**STAFF REPORT  
KETCHUM PLANNING AND ZONING COMMISSION  
REGULAR MEETING OF December 14, 2021**

**PROJECT:** Grossman Residence – Remodel/Addition

**FILE NUMBER:** P21-89

**APPLICATION TYPE:** Mountain Overlay Design Review

PLANTING PLAN,  
NOTES, &  
SCHEDULE

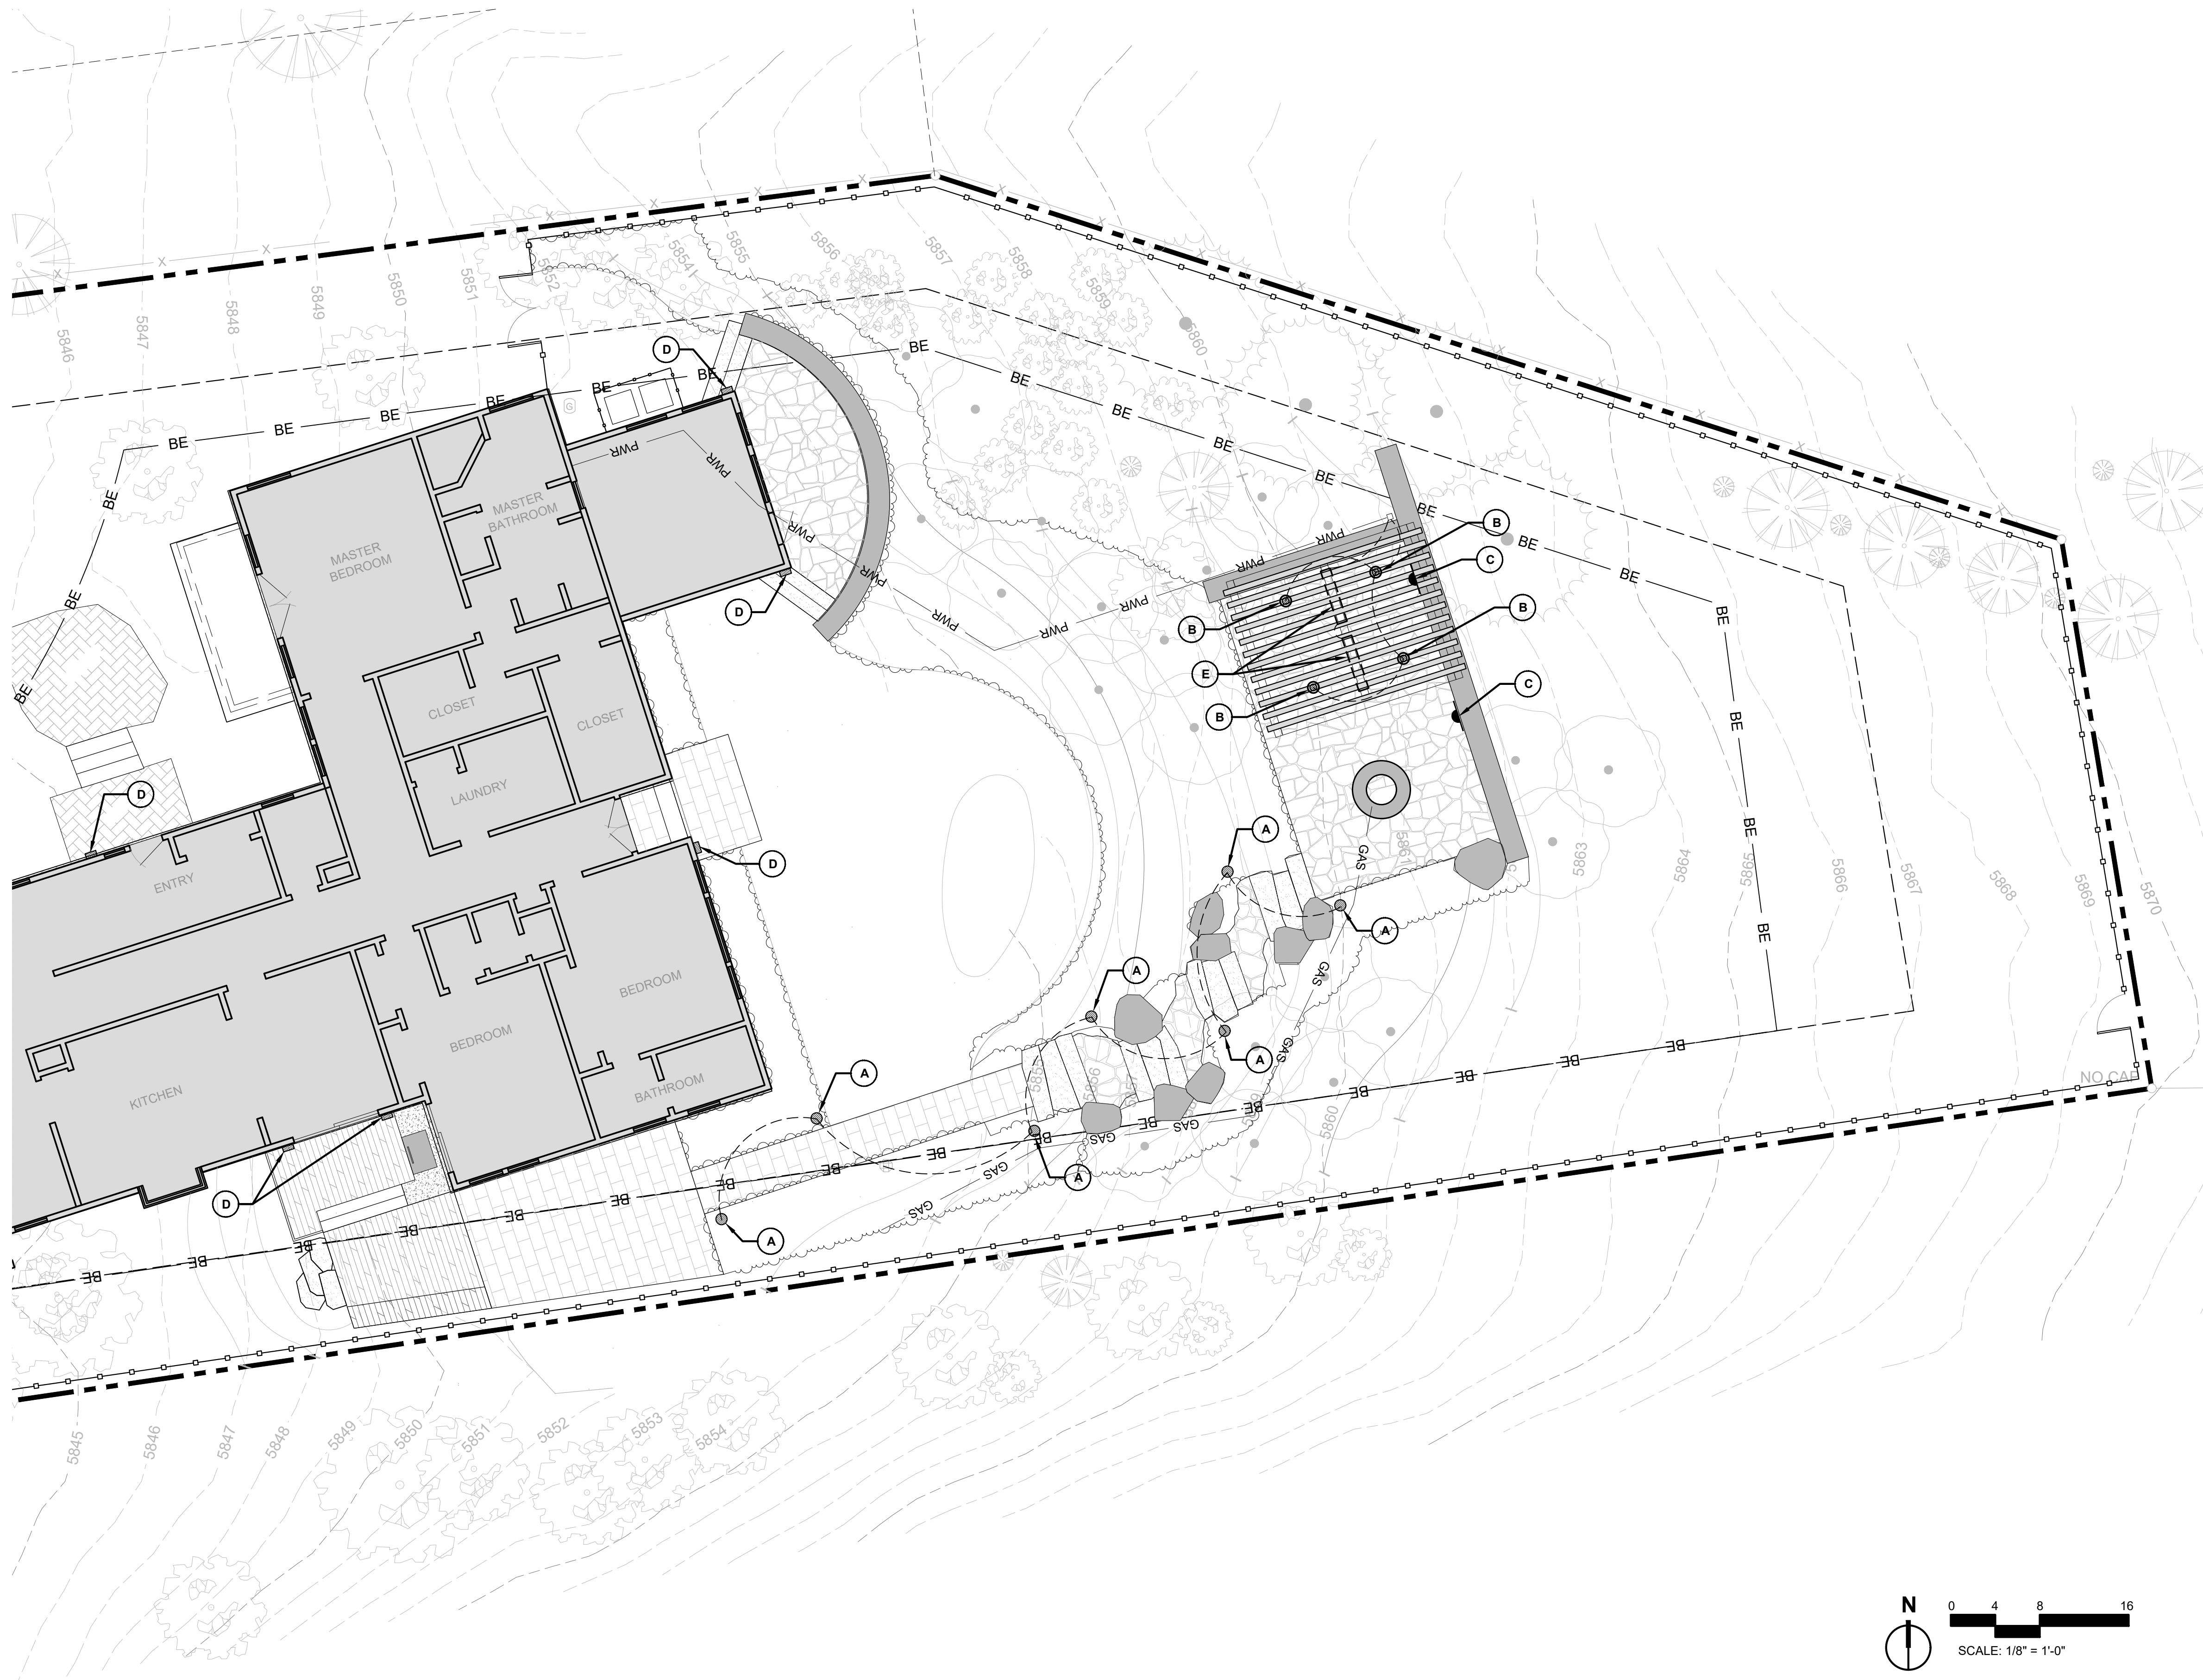
<input checked="" type="checkbox"/>	<input type="checkbox"/>	<input type="checkbox"/>	17.96.060(I)(1)	Landscaping is required for all projects.
			Staff Comments	The required landscape plan is indicated on Sheet L-5.0 of the Design Review submittal.
<input checked="" type="checkbox"/>	<input type="checkbox"/>	<input type="checkbox"/>	17.96.060(I)(2)	Landscape materials and vegetation types specified shall be readily adaptable to a site's microclimate, soil conditions, orientation and aspect, and shall serve to enhance and complement the neighborhood and townscape.
			Staff Comments	The proposed landscape plan (Sheet L-5.0) includes shrub groupings comprised of five (5) Serviceberry as well as five (5) Diabolo Purple Ninebark. Fourteen (14) Quaking Aspen are proposed to be planted as to replace the existing aspens that are proposed for removal. Serviceberry, ninebark and aspen are all drought tolerant species and adaptable to the Wood River Valley climate. The landscape plan complements the single-family residence and adjacent neighborhood.
